Access Compliance Report

Public Rights-of-Way

(Curb Ramps)

Intersection ID: 2743	Main Street: BELL'S_MILL_DR	Cross Street: HIGHLAND_CREEK_PY	Location: NW
ADA ID: A4E5EB0BB3A7	Ramp Type: Perp	Initial Pass/Fail: Fail	Overall Compliance: No
		Severity Score: 10

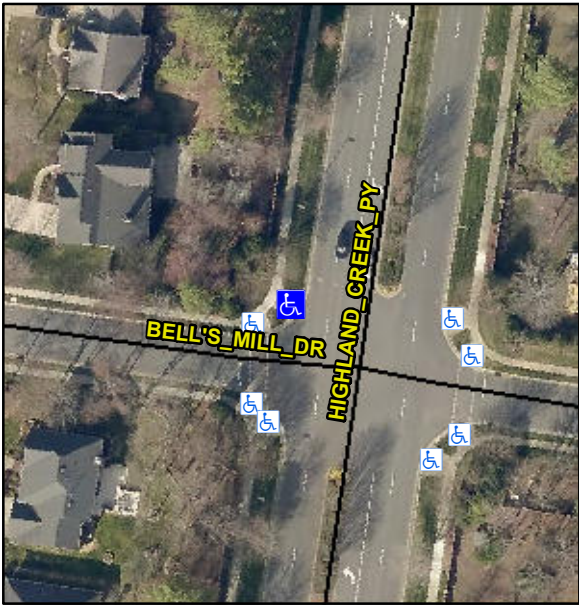
Codes/Mitigation Info/Possible Solution			Field Measurements/Component Compliance					
	Possible Solutions:		Compliance	Description	Data	Compliance	Description	Data
	Remove & Replace Entire Ramp.		N/A	Ramp Length (in)	133.0	Yes	Ramp Slope (%)	5.3
			No	Ramp Width (in)	36.0	No	Ramp XSlope (%)	3.9
			N/A	Flare Type LT	N/A	N/A	Flare Type RT	N/A
			N/A	Flare Slope LT (%)	N/A	N/A	Flare Slope RT (%)	N/A
			N/A	Flare Traversable LT?	N/A	N/A	Flare Traversable RT?	N/A
			N/A	Landing Length (in)	N/A	N/A	DWS Provided?	N/A
			N/A	Landing Width (in)	N/A	N/A	DWS Contrast?	N/A
			N/A	Landing Slope (%)	N/A	N/A	DWS Length (in)	N/A
			N/A	Landing X Slope (%)	N/A	N/A	DWS Full Width?	N/A
<p>Surveyor Notes:</p> <p>N/A</p> <p>PROW/ADA:</p> <p>R304.5.1, R304.5.3</p>			N/A	Landing Curb? (Y/N)	N/A	N/A	DWS Offset (in)	N/A
			N/A	Shared Landing?	N/A			
			N/A	Gutter Ponding?	N/A	N/A	Gutter Slope (%)	N/A
			N/A	Gutter Lip Ht (in)	N/A	N/A	Gutter X Slope (%)	N/A

N/A	Painted X Walk1?	No	N/A	Painted X Walk2?	N/A
				X Walk 1 Direction	To SE		X Walk 2 Direction	N/A
			N/A	X Walk 1 Width (in)	N/A	N/A	X Walk 2 Width (in)	N/A
				X Walk 1 Slope (%)	1.9		X Walk 2 Slope (%)	N/A
				X Walk 1 X Slope (%)	2.8		X Walk 2 X Slope (%)	N/A
			N/A	Ramp inside XWalk1?	N/A	N/A	Ramp inside XWalk2?	N/A
			Road Slope (%)	N/A	N/A	Clear Space?	N/A	
			Road X Slope (%)	N/A	N/A	Clear Space to XWalk (in)	N/A	
		N/A	Any Obstructions?	N/A	N/A	Storm Grate/Utility Hazard?	N/A	
			Obstruction Type			Storm Grate/Utility Type		
					N/A		N/A	
						Yes	Surface Condition? (G/P)	Good
